# Town of Hilton Head Island Regular Design Review Board Meeting

Tuesday, July 24, 2012

# **Building Innovations Selection Center**

## DESIGN TEAM/DRB COMMENT SHEET

DATE: 07-05-2012  
PROJECT NUMBER: 01-12006  
SHEET TITLE: Site Plan

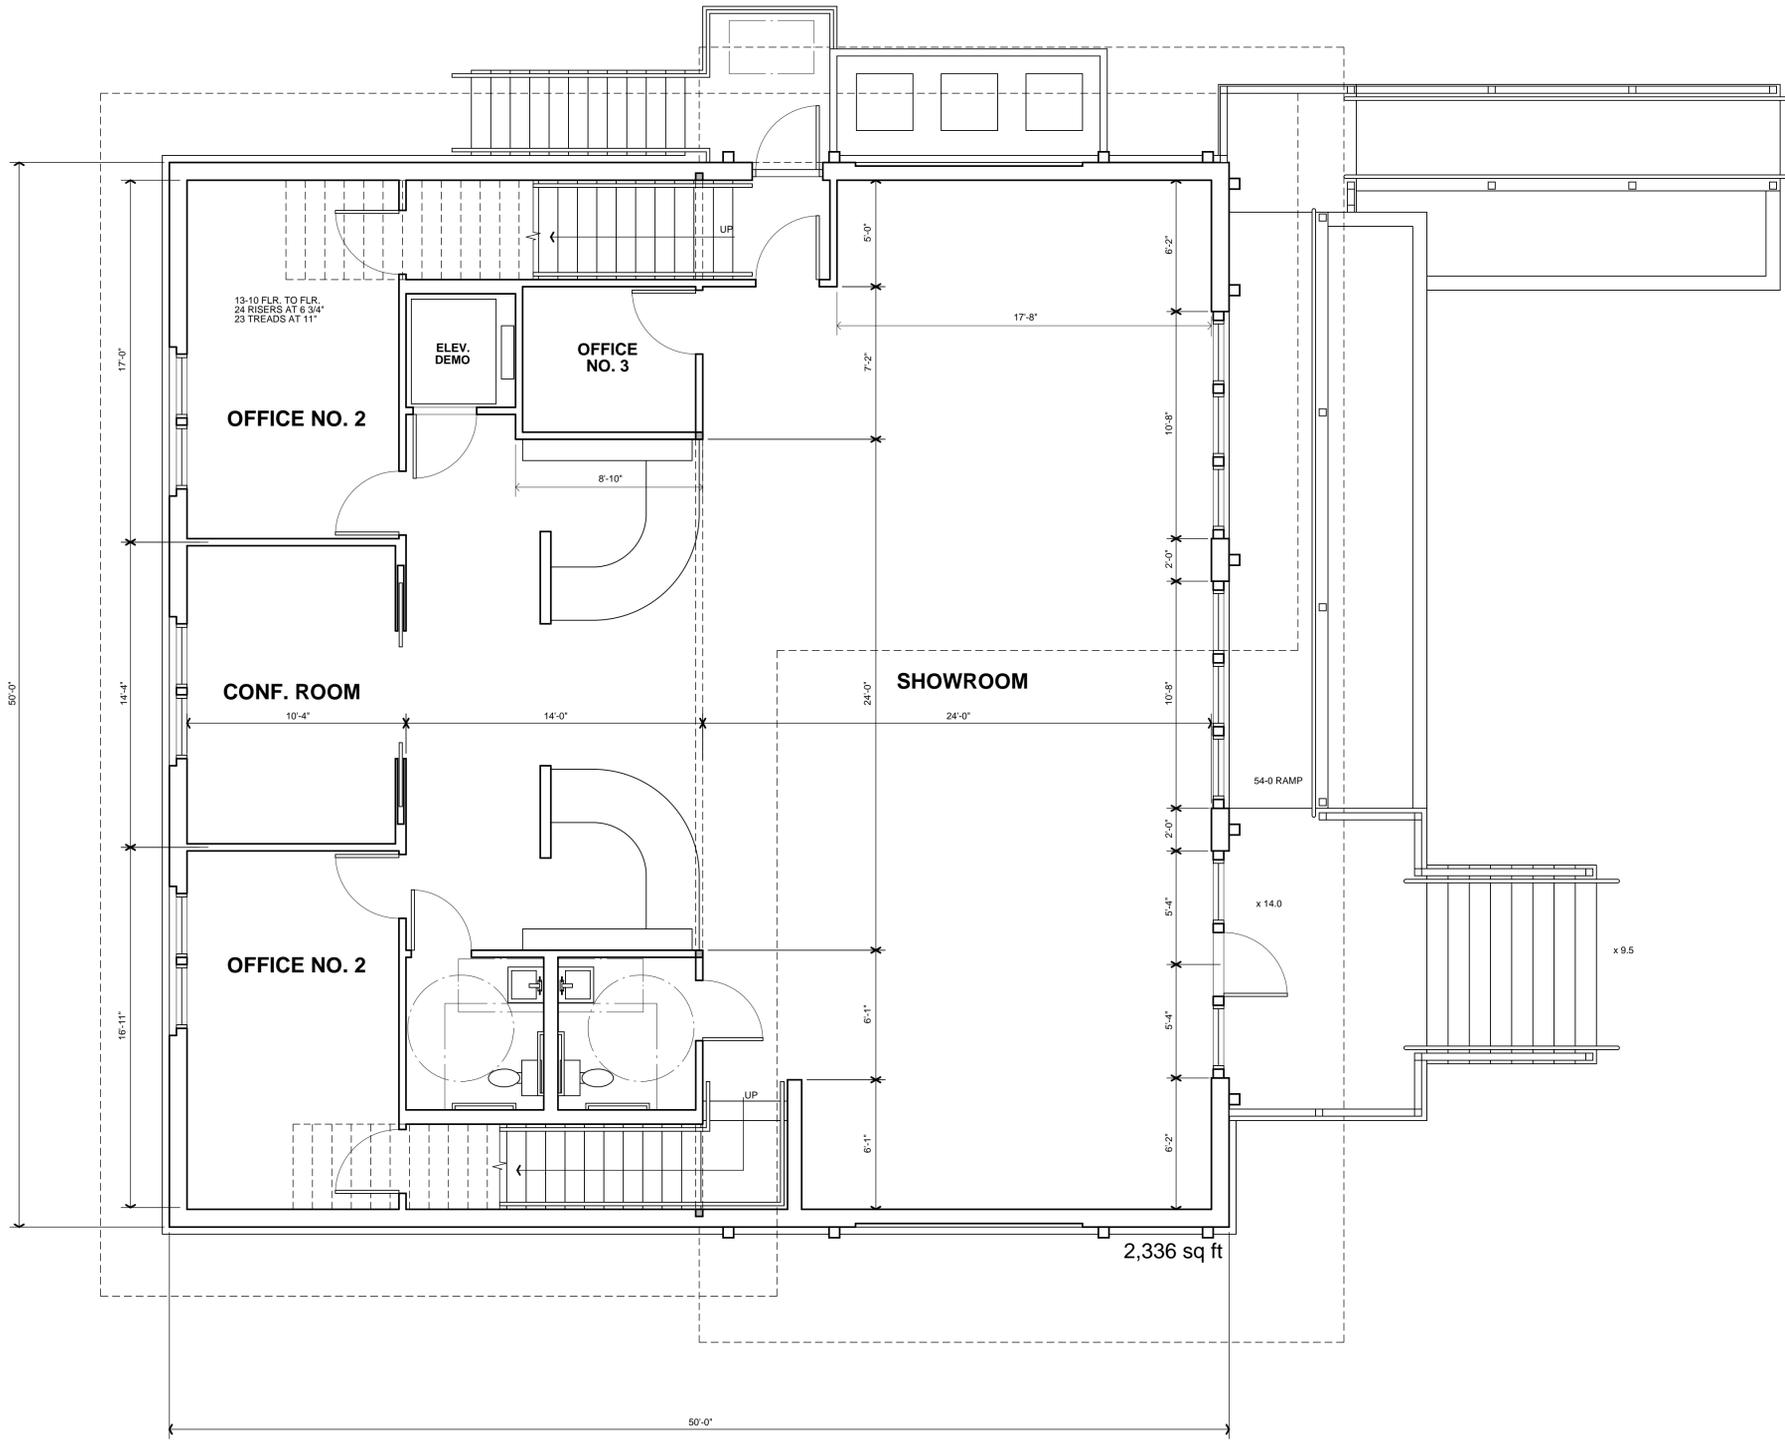
Applicant has applied to the BZA for a variance to encroach into the buffers. Denial of this variance request may require modifications to the building footprint and/or site plan.

**A1** RIGHT ELEVATION

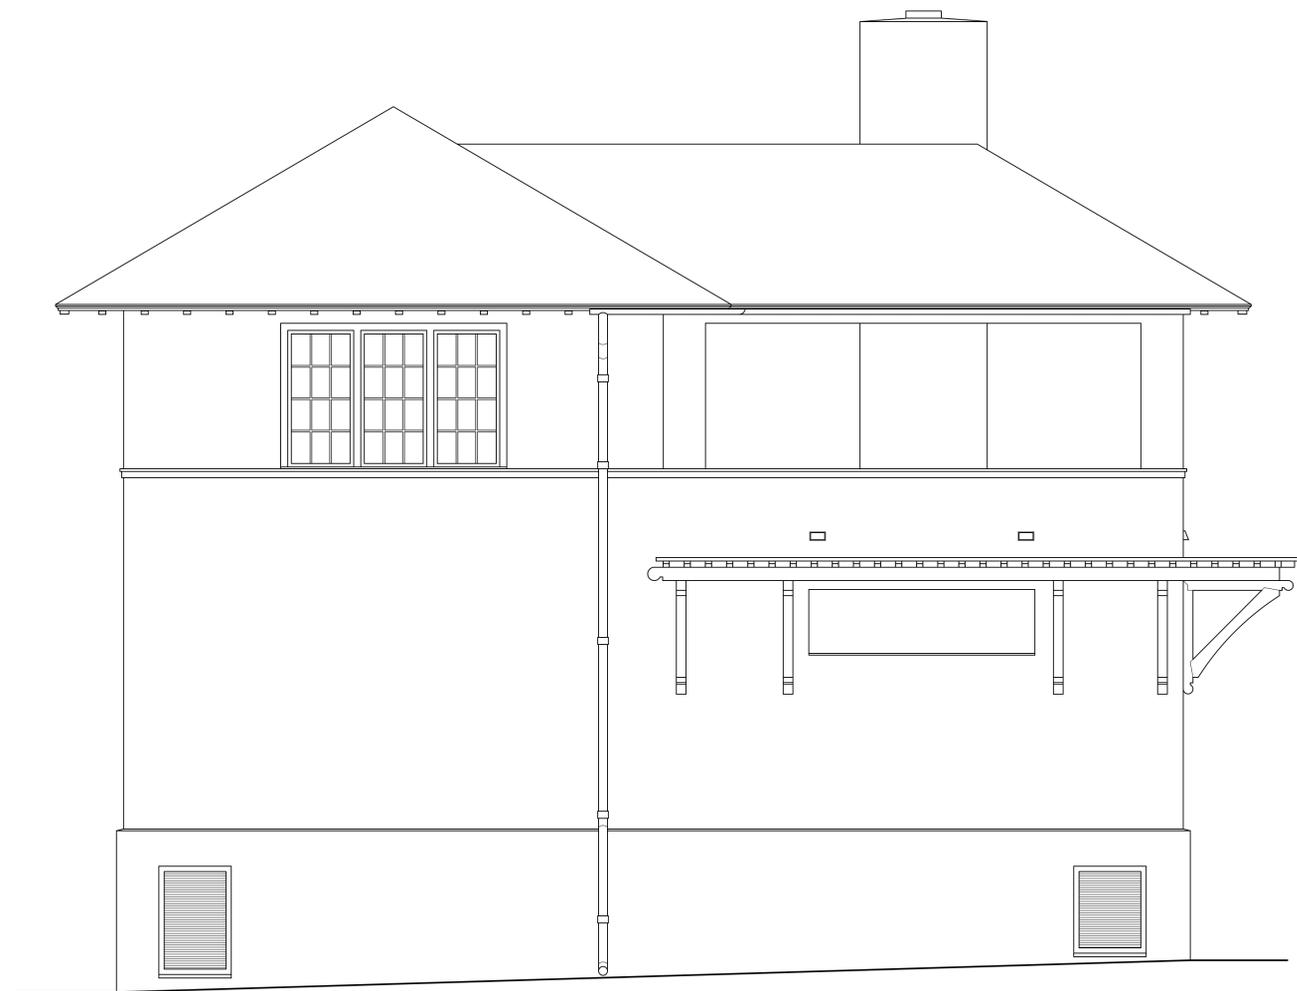
All facades are have equal design characteristics	<input type="checkbox"/>	<input checked="" type="checkbox"/>	<input type="checkbox"/>	Left & Right elevations have less detail but face side-yard buffer.
Avoids monotonous planes or unrelieved repetition	<input checked="" type="checkbox"/>	<input type="checkbox"/>	<input type="checkbox"/>	
Has a strong roof form with enough variety to provide visual interest	<input checked="" type="checkbox"/>	<input type="checkbox"/>	<input type="checkbox"/>	
Minimum roof pitch of 6/12	<input checked="" type="checkbox"/>	<input type="checkbox"/>	<input type="checkbox"/>	
Overhangs are sufficient for the façade height.	<input checked="" type="checkbox"/>	<input type="checkbox"/>	<input type="checkbox"/>	
Forms an details are sufficient to reduce the mass of the structure	<input checked="" type="checkbox"/>	<input type="checkbox"/>	<input type="checkbox"/>	
Human scale is achieved by the use of proper proportions	<input checked="" type="checkbox"/>	<input type="checkbox"/>	<input type="checkbox"/>
